MEETING:	REGULAR MEETING OF THE PLAN COMMISSION
DATE AND TIME:	Monday, August 14, 2023 6:30 PM
LOCATION:	Germantown Village Hall Board Room N112 W17001 Mequon Road

PLANNED DEVELOPMENT DISTRICT (PDD) & CERTIFIED SURVEY MAP (CSM) APPLICATIONS

Village Planner Report

Hans Dawson, agent for Moraine Development LLC, property owner, is requesting approval of a rezoning application to create a Planned Development District (PDD) and Certified Survey Map (CSM) for purposes of restoring and redeveloping the former gravel mining site into a 126-acre residential conservation development located at W218 W11546 Appleton Avenue.

CERTIFIED SURVEY MAP NO. _____

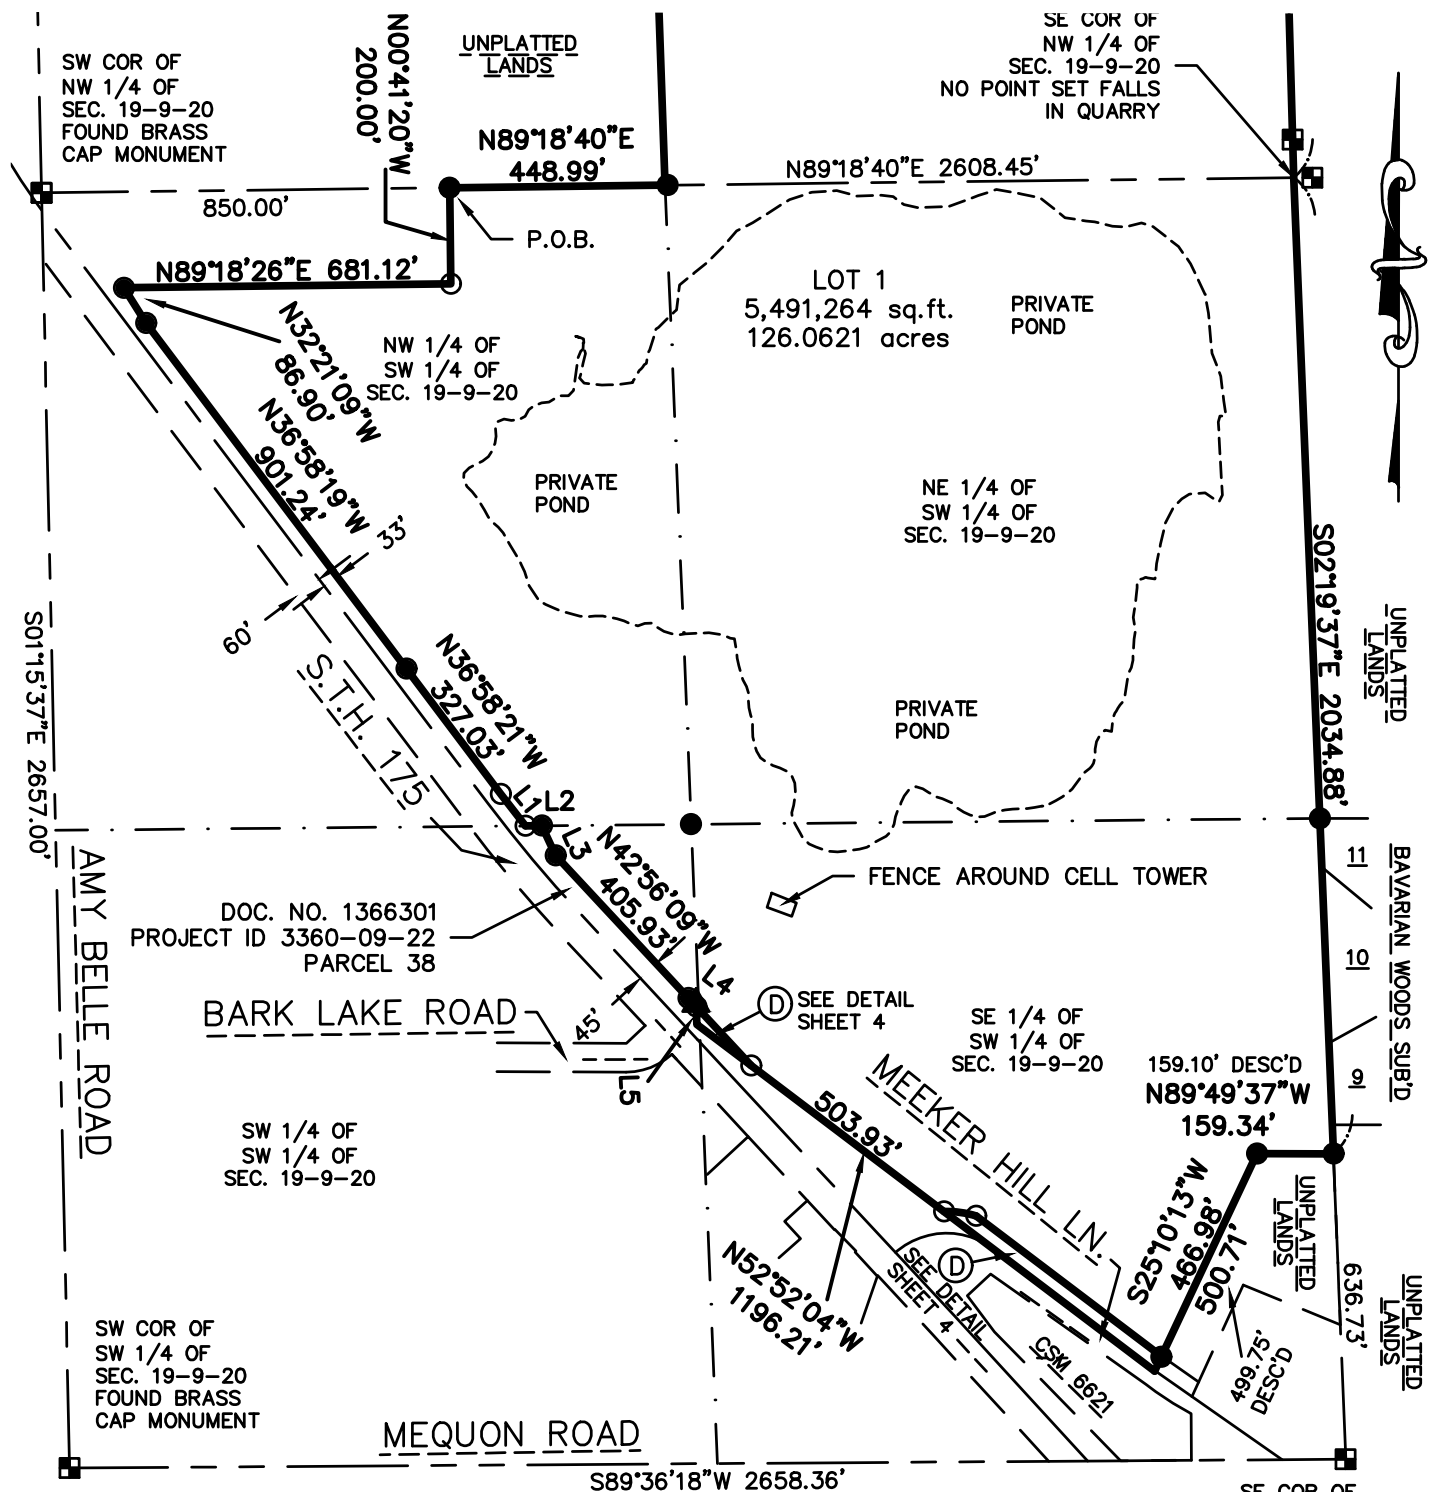
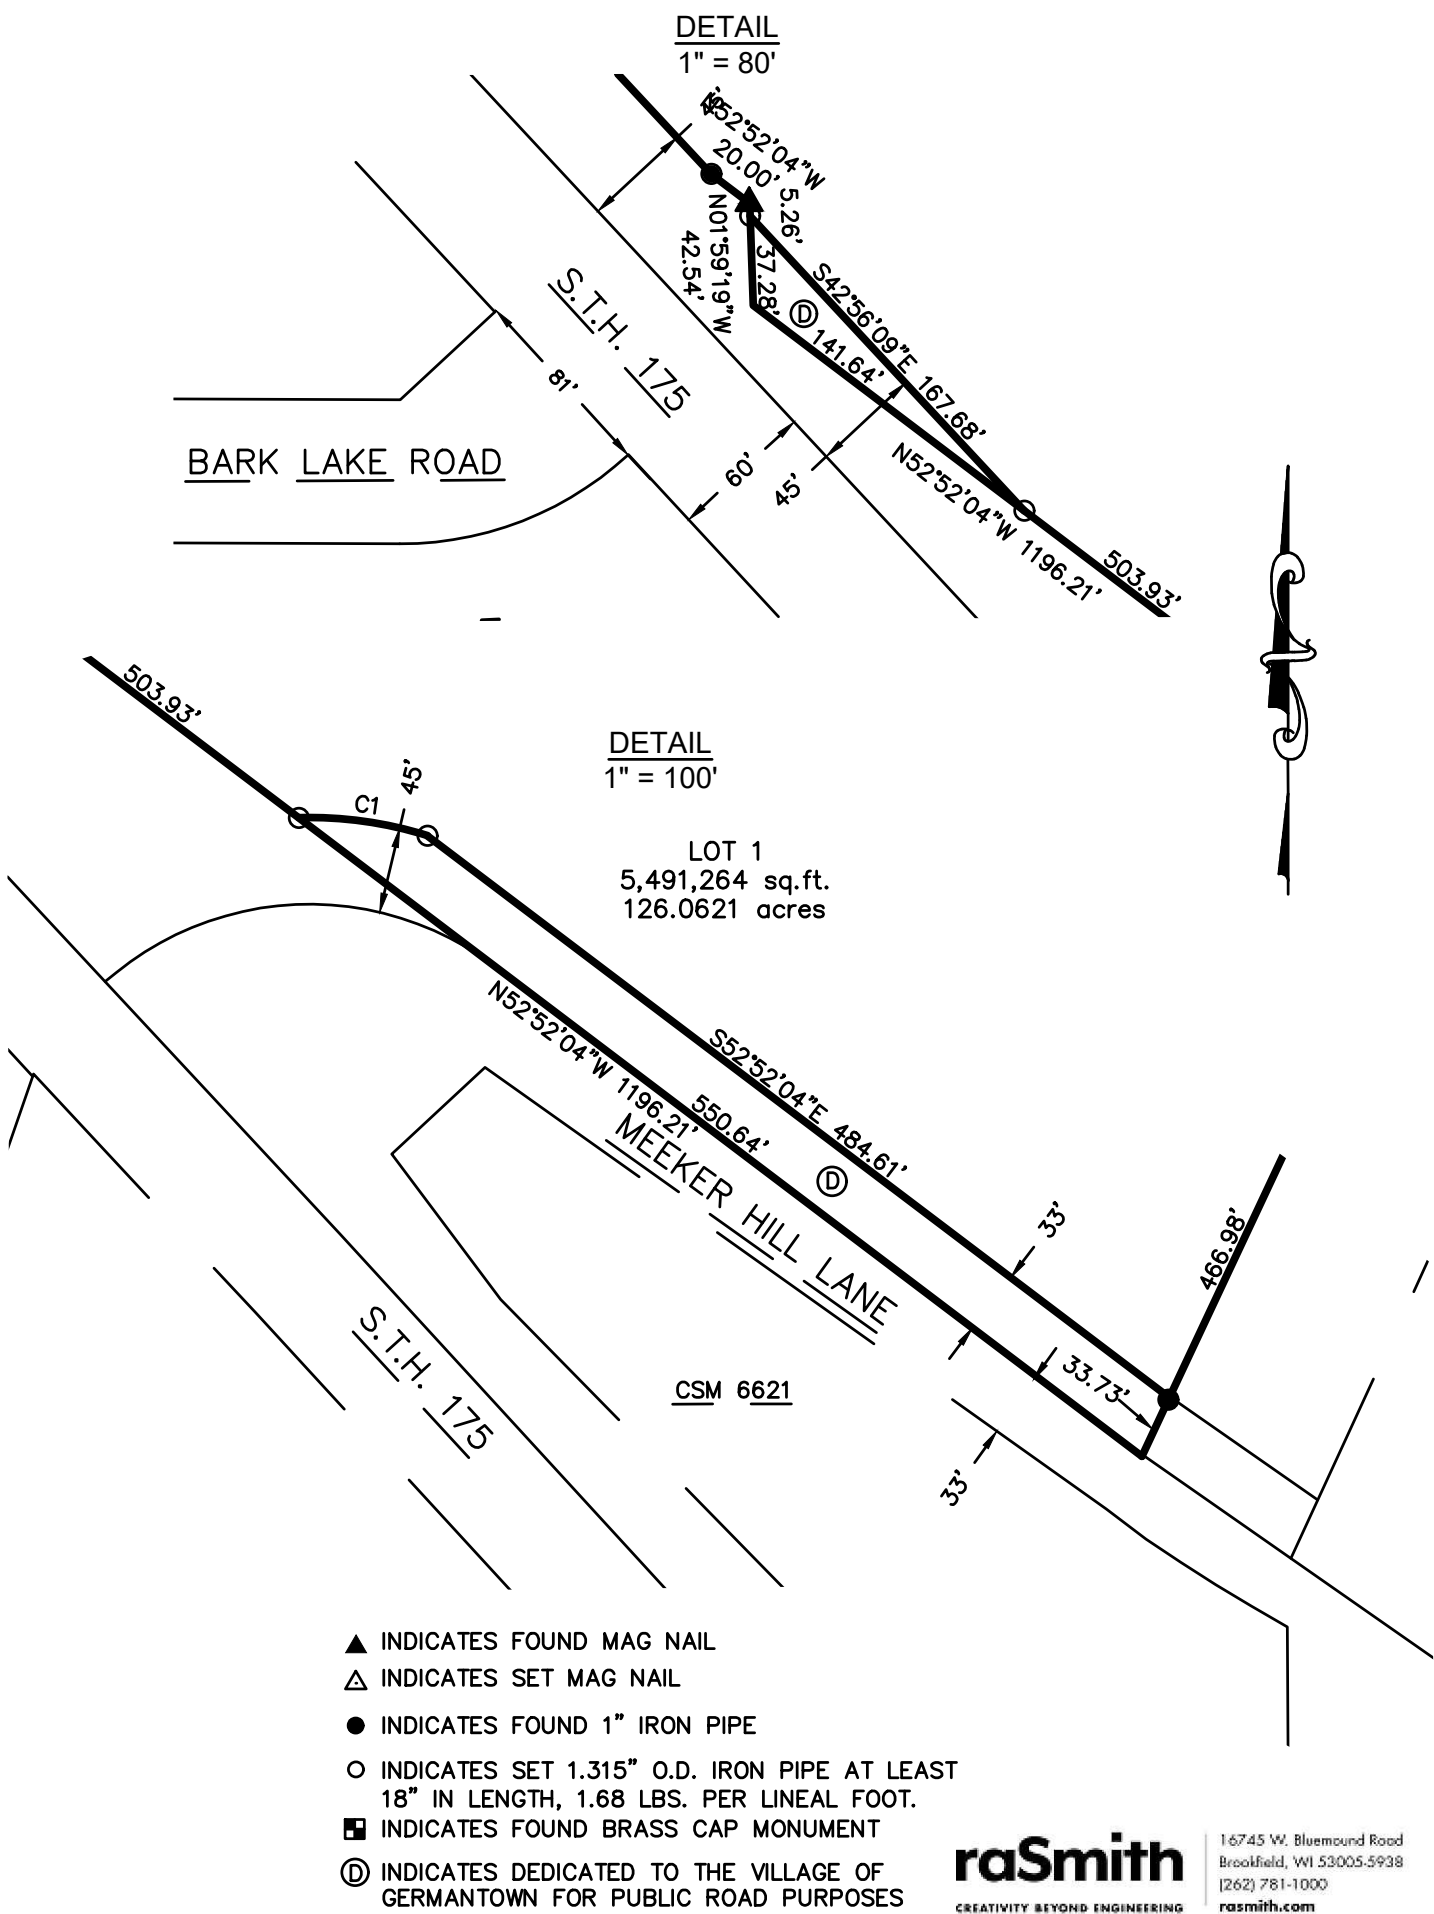
4. Curve data should be labeled on sheet 4 for C1.
5. The Village Clerk's name is Erin Hirn, Interim Village Clerk.
6. A mortgage certificate should be included, if applicable.

7. A table should be provided showing bearings and distances for L1, L2, L3, L4 and L5.
8. Label acreage for roadway dedications.
9. Bearing N 52-52-04 W on the top of sheet 4 detail should be moved to avoid overlay of ROW dimension.

C1.02

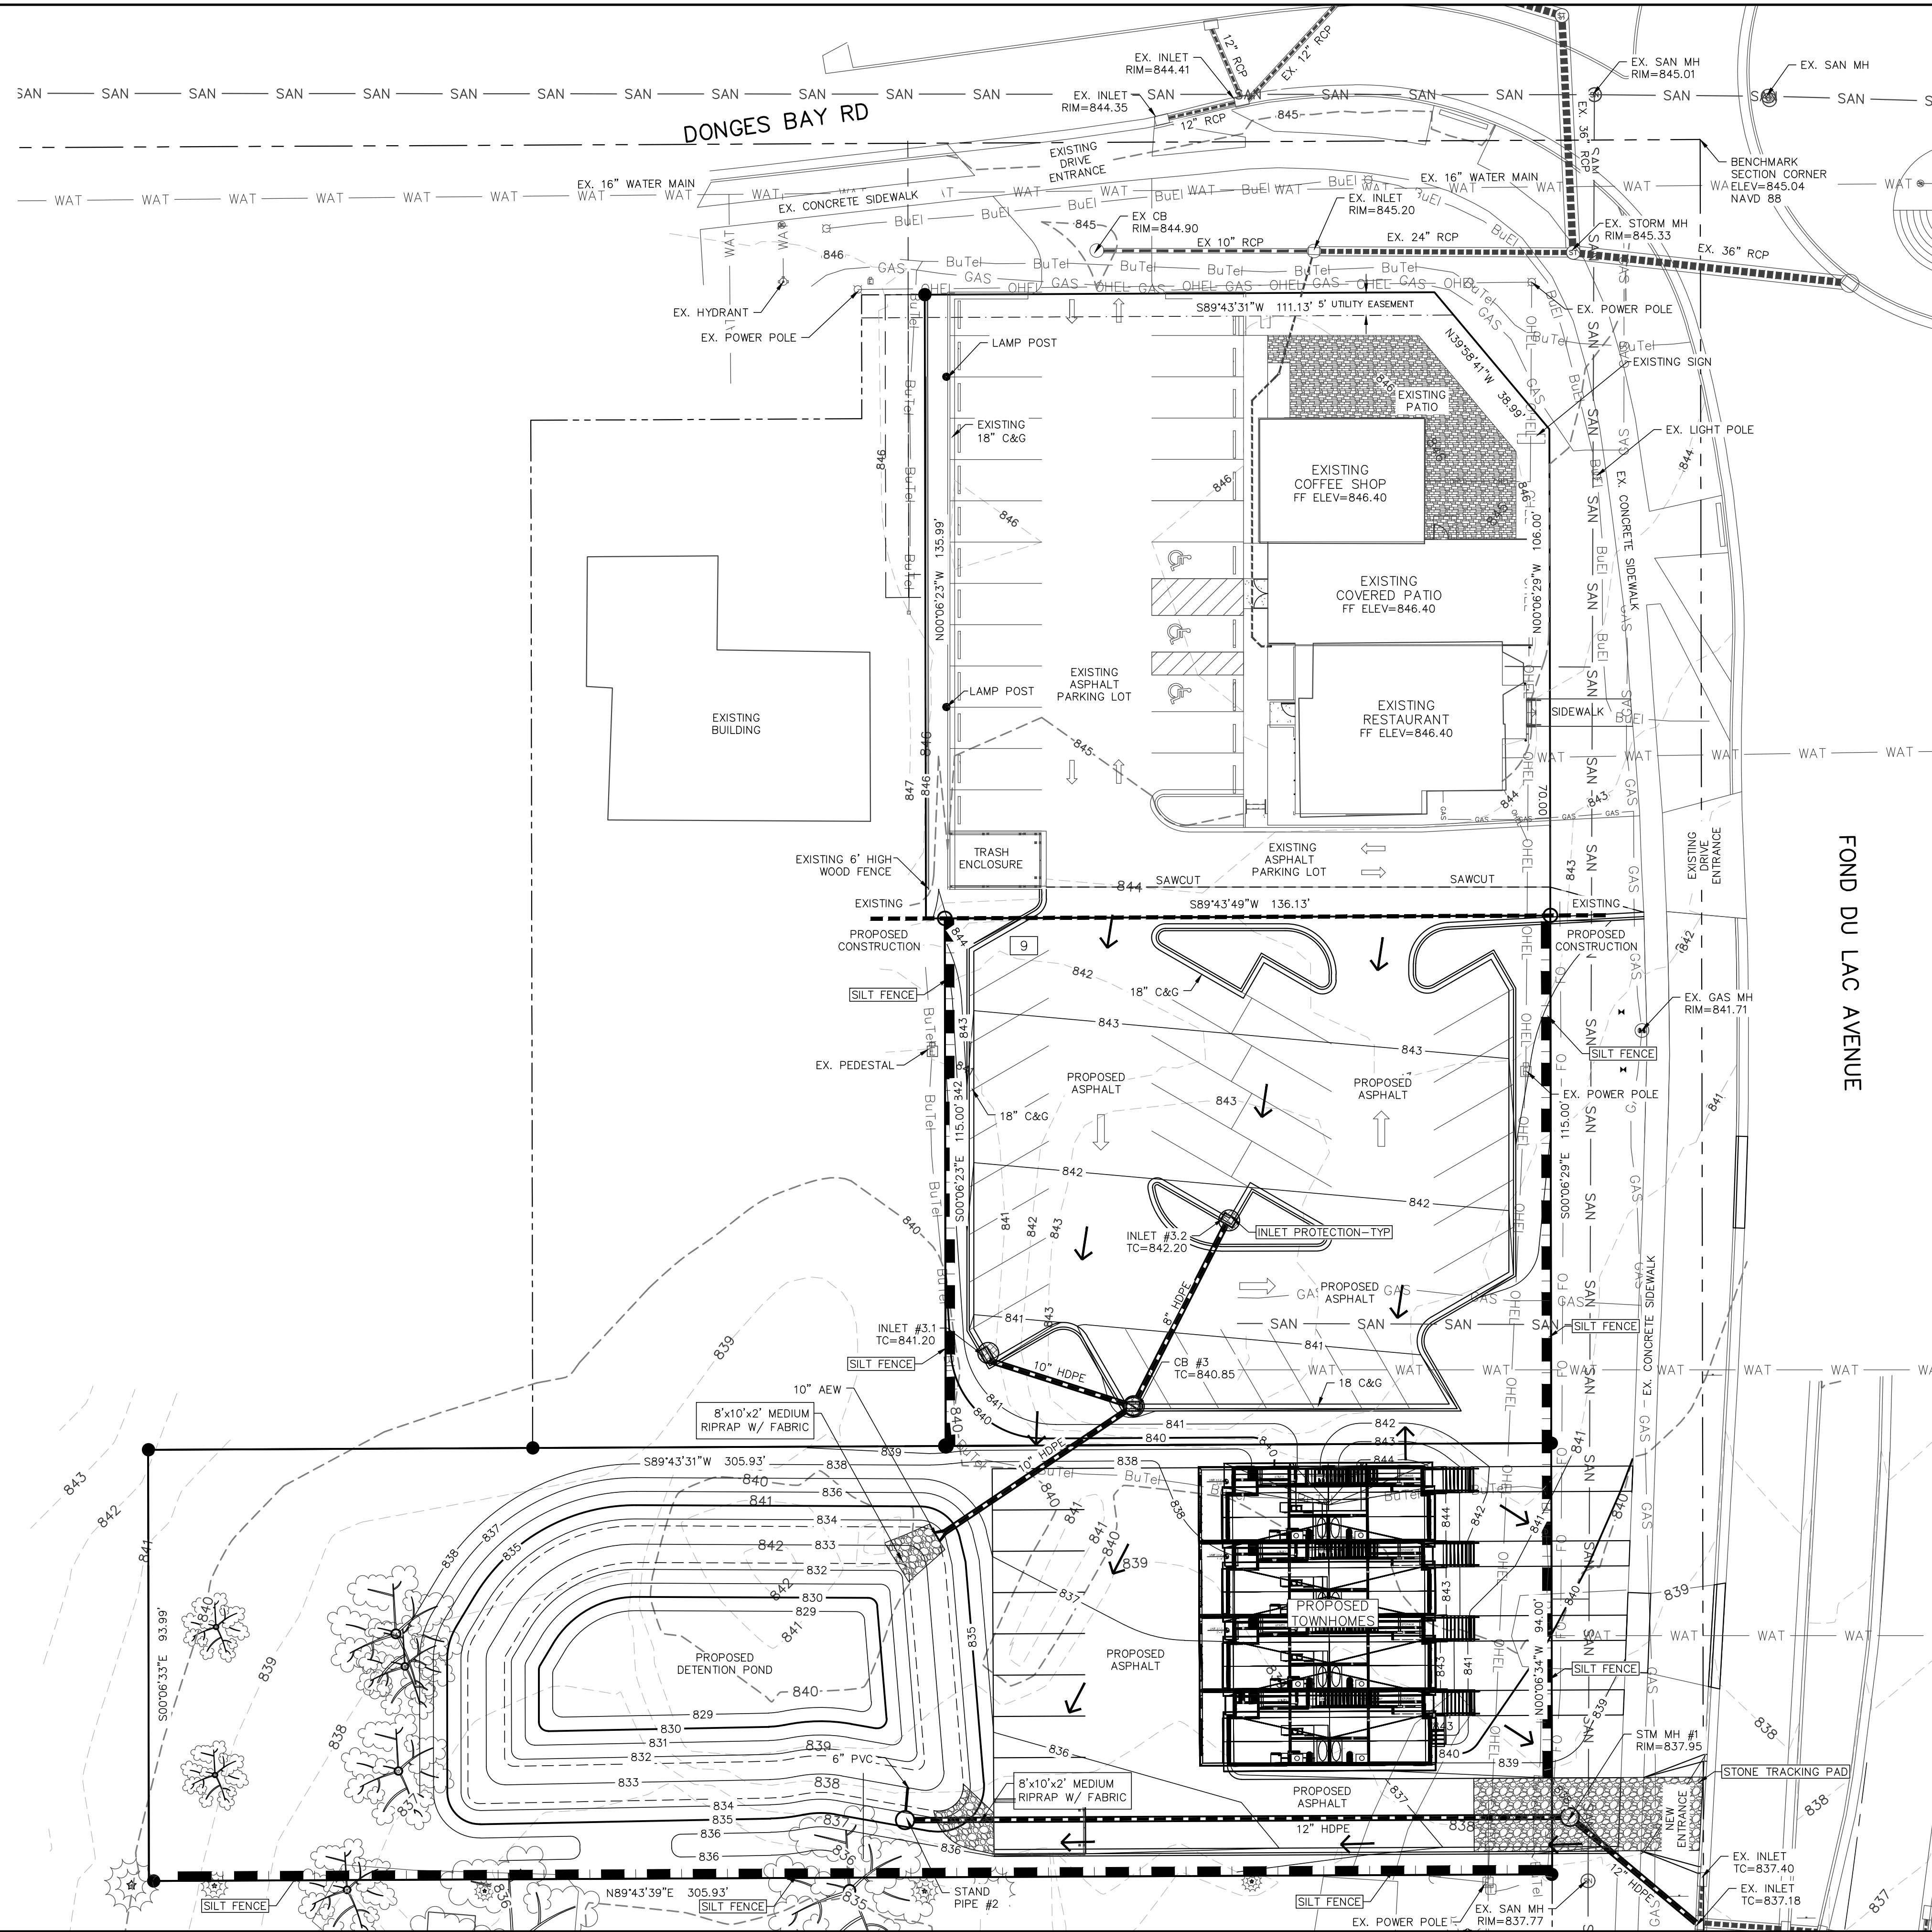
As shown on Sheet C1.02, the proposed setback from the townhouse building to the north property line (proposed parking lot property line) is only 5 feet. Again, a building setback of only 5 from the property (an additional 7 feet to the parking lot pavement edge) leaves little space to provide an adequate landscape buffer to the proposed commercial parking lot serving the proposed renovated restaurant (existing bar).
